DUKE POWER COMPANY

May 29, 1984

Re: Catawba Nuclear Station
Docket Nos. 50-413 and 50-414

In regard to your April 10, 1984 letter requesting additional information, please find attached three (3) copies of Duke's responses to the questions pertaining to the Offsite Dose Calculation Manual for the Catawba Nuclear Station. Please be advised that Section C4.3, "Fuel Cycle Calculations," is incomplete. This information will be provided by June 4, 1984.

FIGURE C1.0-2
CATAWBA NUCLEAR STATION
GASEOUS RADWASTE SYSTEM

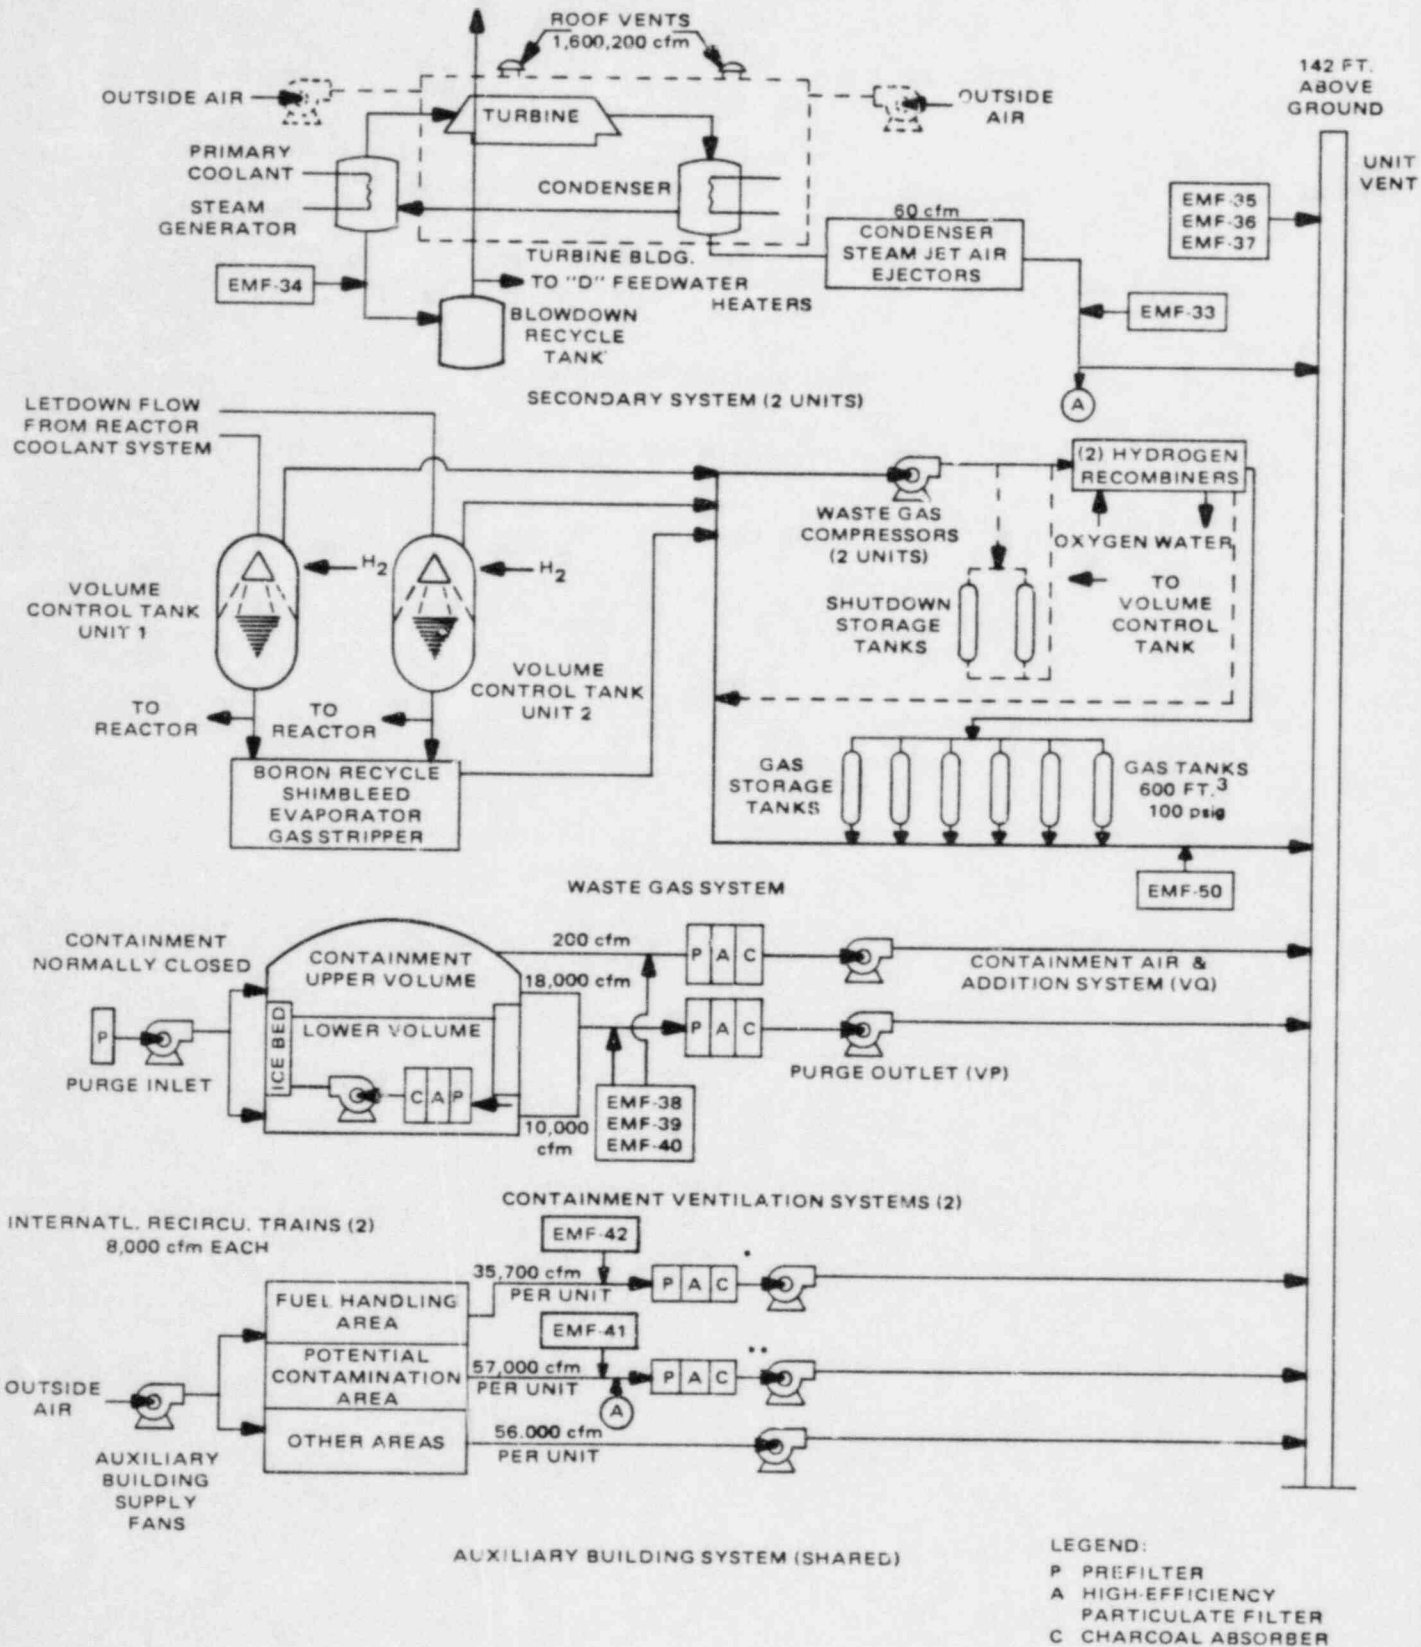
Comment: Monitors are not designated for the following effluent streams; Hydrogen Monitors at the recombiners; Vent System; Containment Purge System; Auxiliary Building Ventilation; Fuel Storage Area Ventilation System.

Comment: 1) Indicate route of off-normal steam generator blowdown vent exhaust.

Comment: 2) Indicate where hydrogen and oxygen are monitored in the waste gas holdup system.

Comment: 3) Indicate (the) location of flow and radiation monitors and continuous samplers and type of continuous samplers for effluents from the waste gas holdup, condenser evacuation, auxiliary building ventilation, fuel storage area ventilation, containment purge, containment ventilation, and vent systems.

Comment: Identify all environmental release points.

Response: EMF designation will be added to each of the above locations except "Hydrogen Monitors at the Recombiners." This is not an effluent stream and no EMF monitor is required by Catawba's Technical Specifications.

Response: Figure C1.0-2 will be revised to provide this information.

Response: Oxygen and hydrogen monitors are located upstream and downstream of the hydrogen recombiners. Since these monitors are not on an effluent stream and do not monitor radiation, Duke Power Company feels that they should not be presented in a document which deals with off-site doses.

Response: EMF designations will be added to each of above locations.

Response: Gaseous effluent environmental release points are designated on Figure 5.1-4 of Catawba's Technical Specifications. Duke Power Company feels that this would be a duplication of information already presented in a more tightly controlled document. With this explanation, no action is planned.

CATAWBA NUCLEAR STATION
MONITORING PROGRAM LOCATIONS
FIGURE C5.0-1
(1 OF 2)

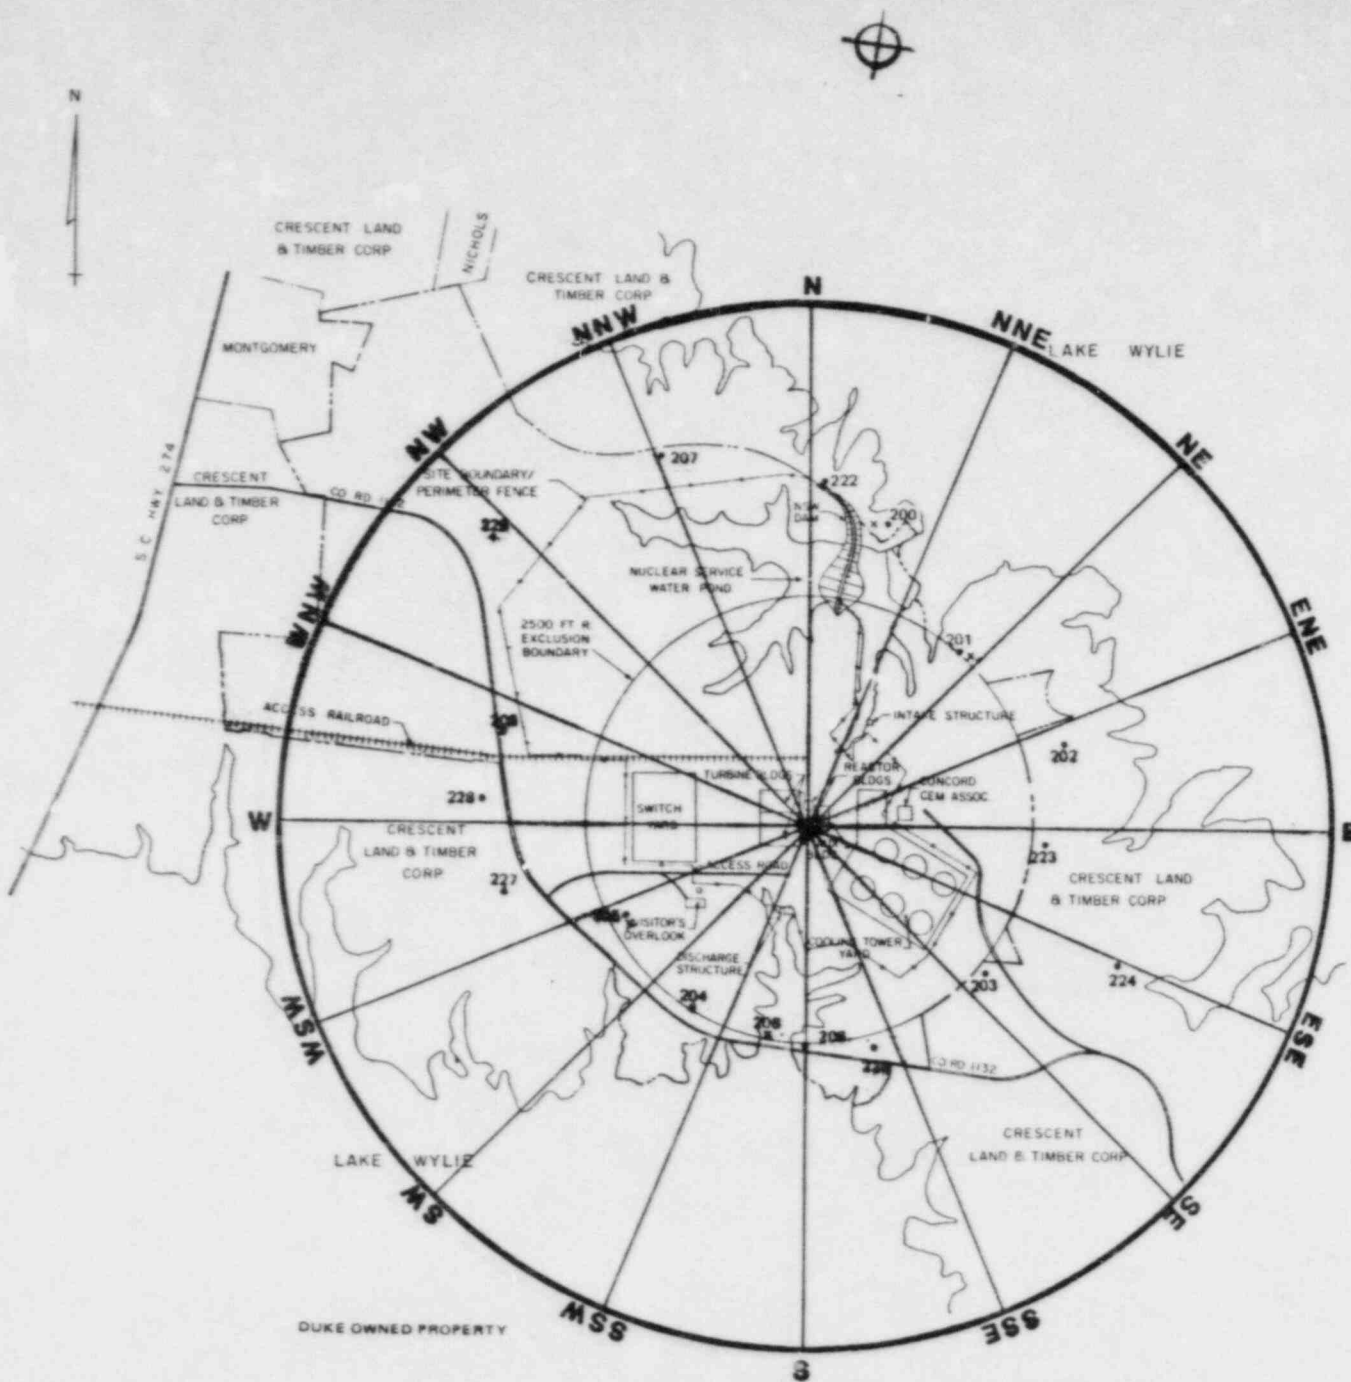
Comment: 2) A foldout figure is needed for Figure C5.0-1 (in order) to make it readable.

- a. Sector information was inadvertently left off Figure C5.0-1. It will be added.
- b. The distance to the controlling receptor location is listed in the Section of the ODCM that bases its calculations on this information, i.e., Section C4.3.2.2, page C-15. Duplication of information is unnecessary. No action is planned.
- c. Exposure pathway information is also listed in this manner, i.e., Section C4.3.2.2, page C-15. Again this would be a duplication of information and is unnecessary. No action is planned.
- d. Age group information has been provided in the assumption for each calculation where this information is used, i.e., Section C4.3.2.2, page C-15. Again this would be a duplication of information and is unnecessary. No action is planned.
- e. $\overline{X/Q}$ and $\overline{D/Q}$ values are listed on Tables C-4.0-1 and C-4.0-2. No action is planned.

Response: Ten copies of a two-color 8½ x 17 foldout were included with the ODCM submittal. Additional copies will be submitted with these responses.
